November 26, 2019

## RE: Albuquerque School of Excellence Expansion 13201 Lomas NE Grading and Drainage Plan Stamp Date: 11/20/19 Hydrology File: J22D050

### RE: ALBUQUERQUE SCHOOL OF EXCELLENCE EXPANSION 13201 LOMAS NE GRADING AND DRAINAGE PLAN STAMP DATE: 11/7/19 HYDROLOGY FILE: J22D050

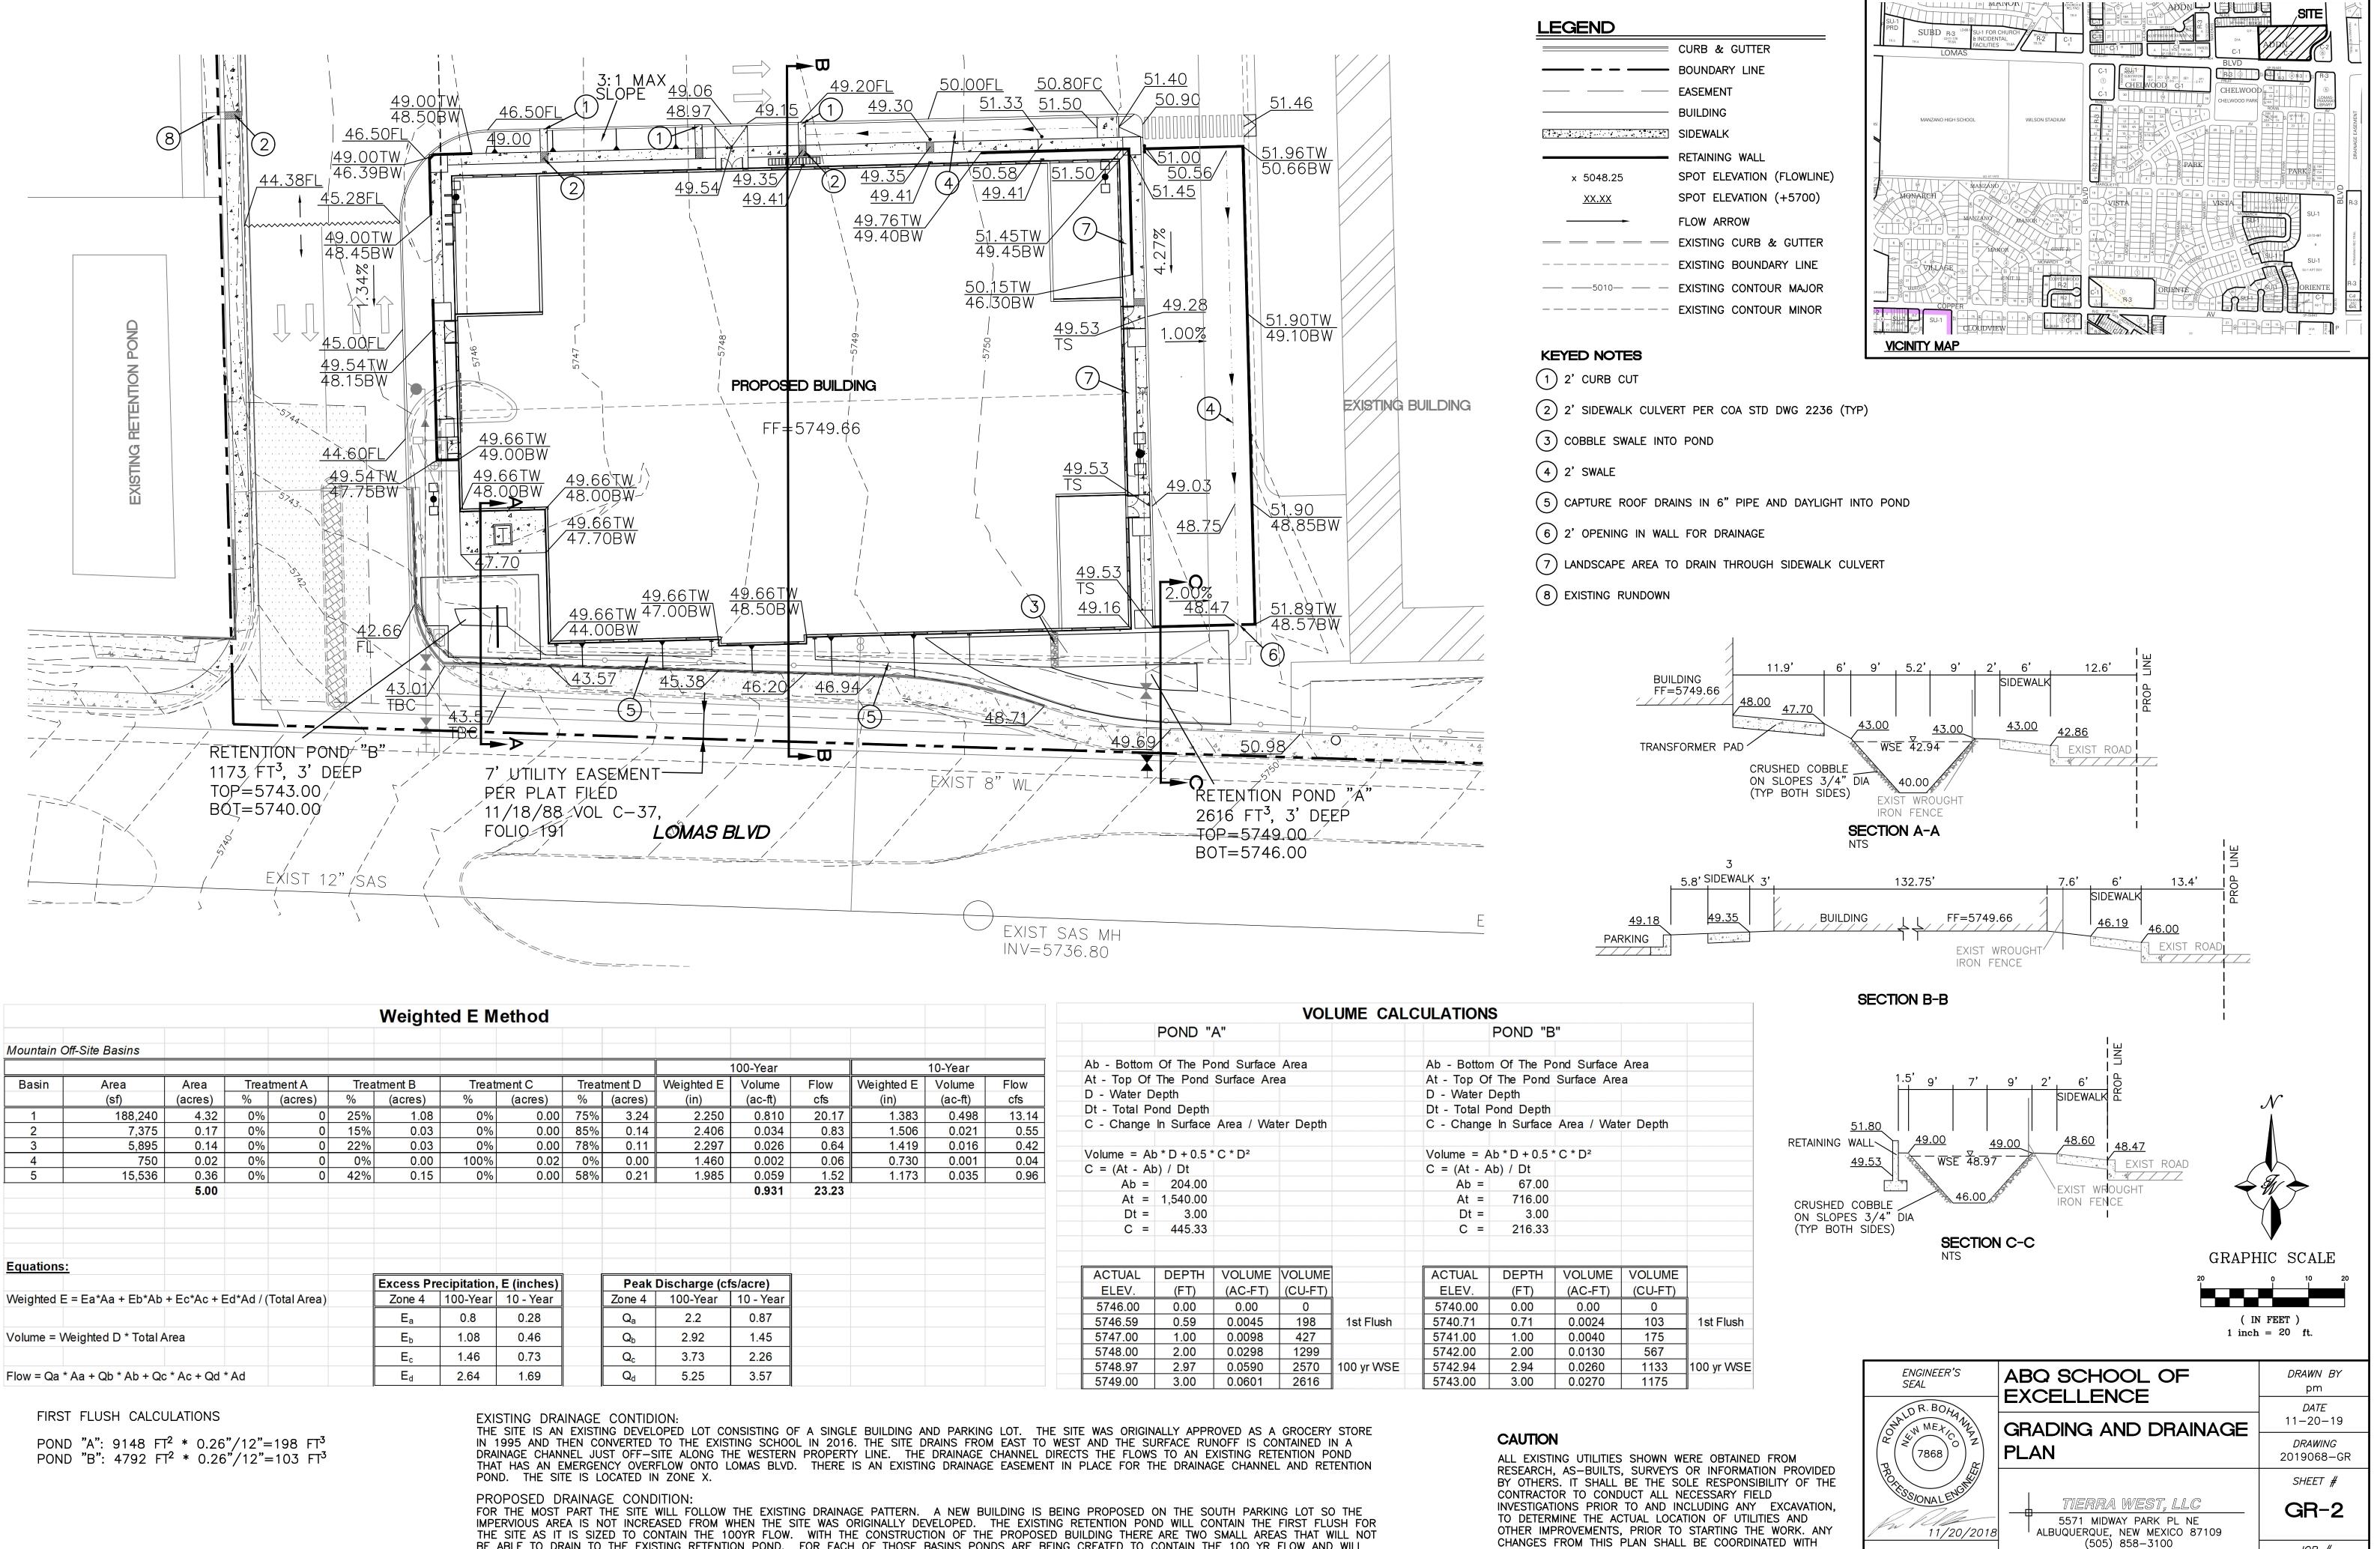
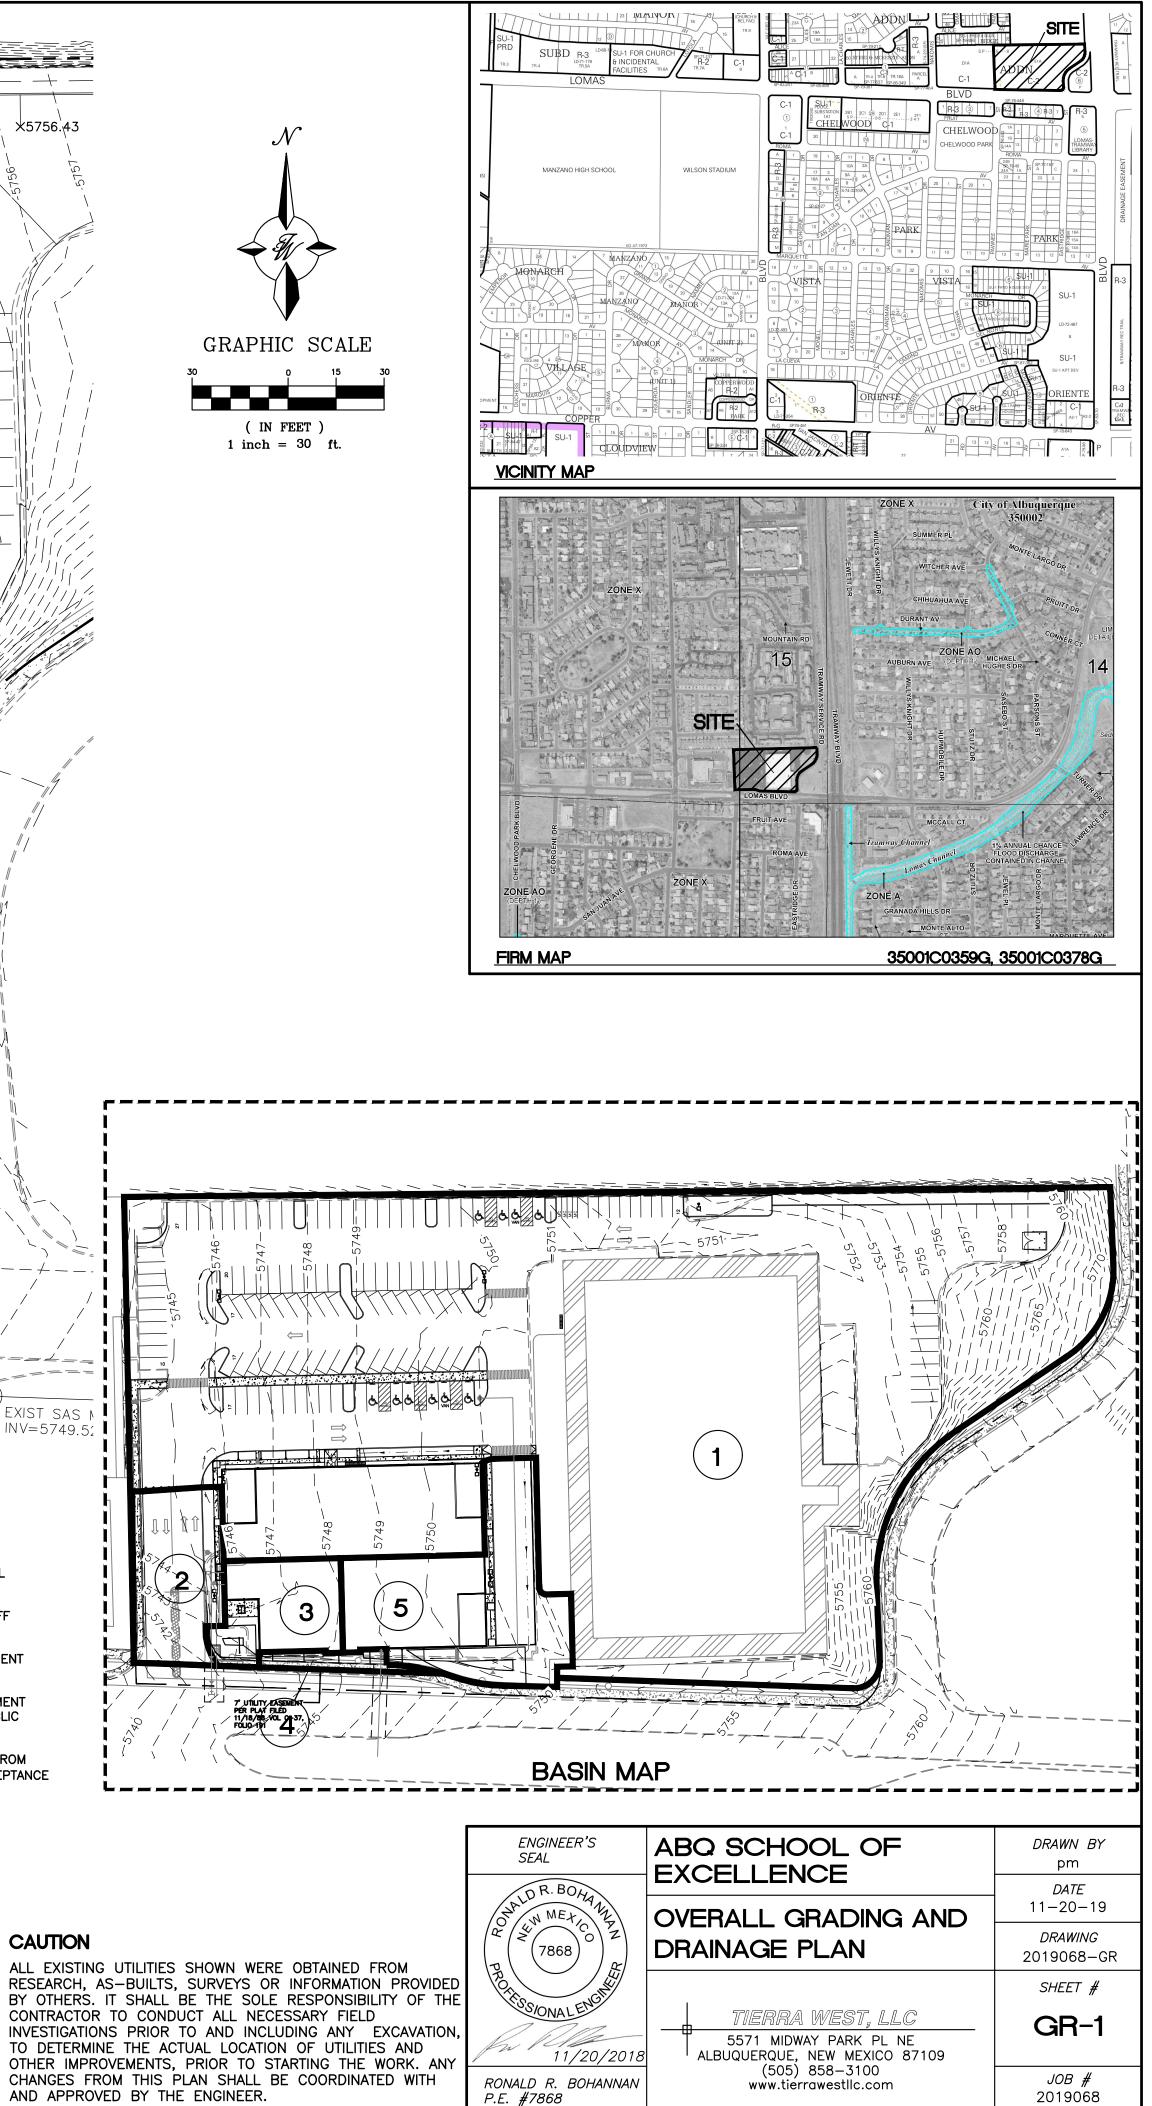
- Please number the pounds and include sections and labels on each with the Stormwater Quality Volume (SWQV) and elevation, the 100-year volume and elevation, the peak 100 year inflow, top of pond elevation. Provide pond volume calculations by contour area; correct the volume on the western pond. The ponds are now labeled and the information is shown on the cross-sections and in the pond volume tables.

- Please include the SWQV calculations. This site qualifies as redevelopment and is only required to retain runoff from the 80<sup>th</sup> percentile storm (Vol. =0.26<sup>n</sup>\*Imp.Area). The storm water quality volumes are now shown on the Grading Plan.

- The eastern (and western) pond cannot encroach on the ROW.
  The previously submitted plan was showing the boundary line in error which is now correct. Neither pond is encroaching in the right-of-way.

- Provide a section though the proposed building and Lomas. Provide stabilization of slopes exceeding 3.1. There's one stem wall elevation called out as TW=43.00 that probably should be 49.66.

Cross-sections were added to the plan and the wall elevations corrected. Slope protection is shown in the cross-sections and called out as crushed cobble 3"-4" in diameter.
